Preference Determination Route BWZ

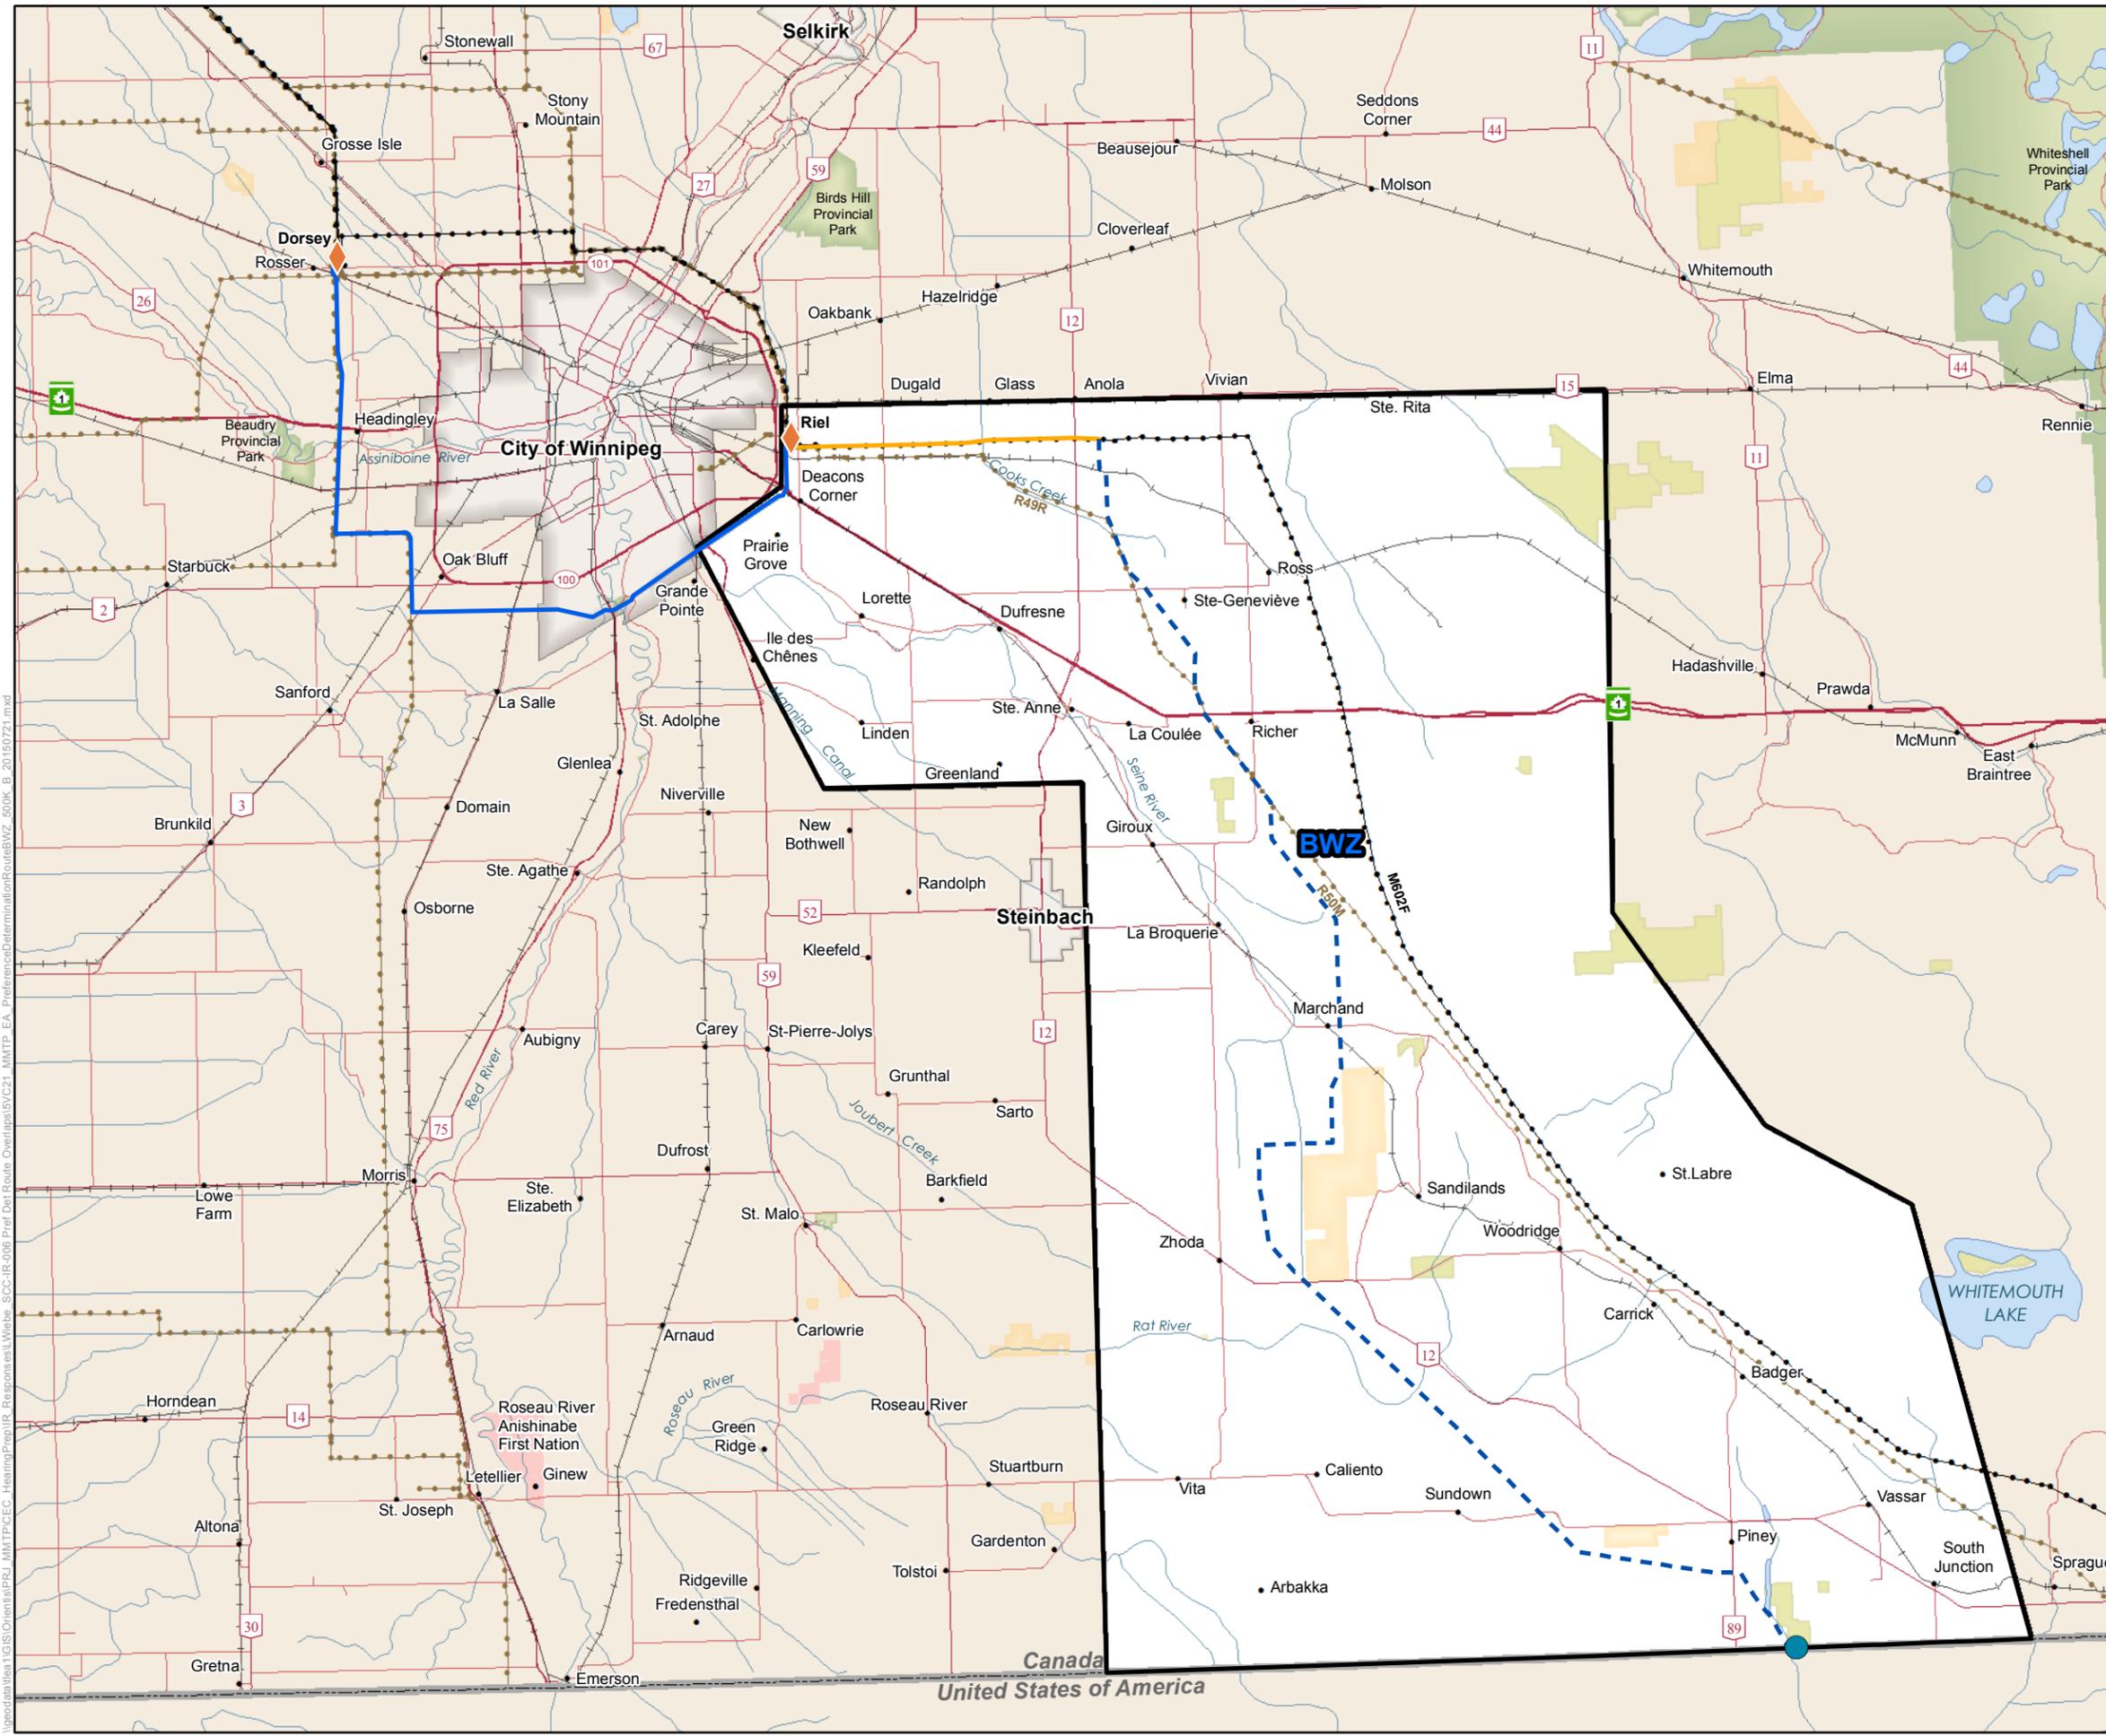
The mapping of the B series of routes (BMX, BMY, BOB, BWZ, BXP) appears to show overlaps of the BOB, BMX and BMY routes.

- (a) Please provide maps that show the total length and location of each of the 5 final routes.
- (b) Provide a table showing the length of overlap of routes with common alignments.

- 1 Because the information was readily available, maps of each of the 5 routes are provided as
- 2 SSC-IR-006_Attachment(1-6). A table showing the segments included in each route, route
- 3 length and segment length is attached to show which segments overlap on each route.
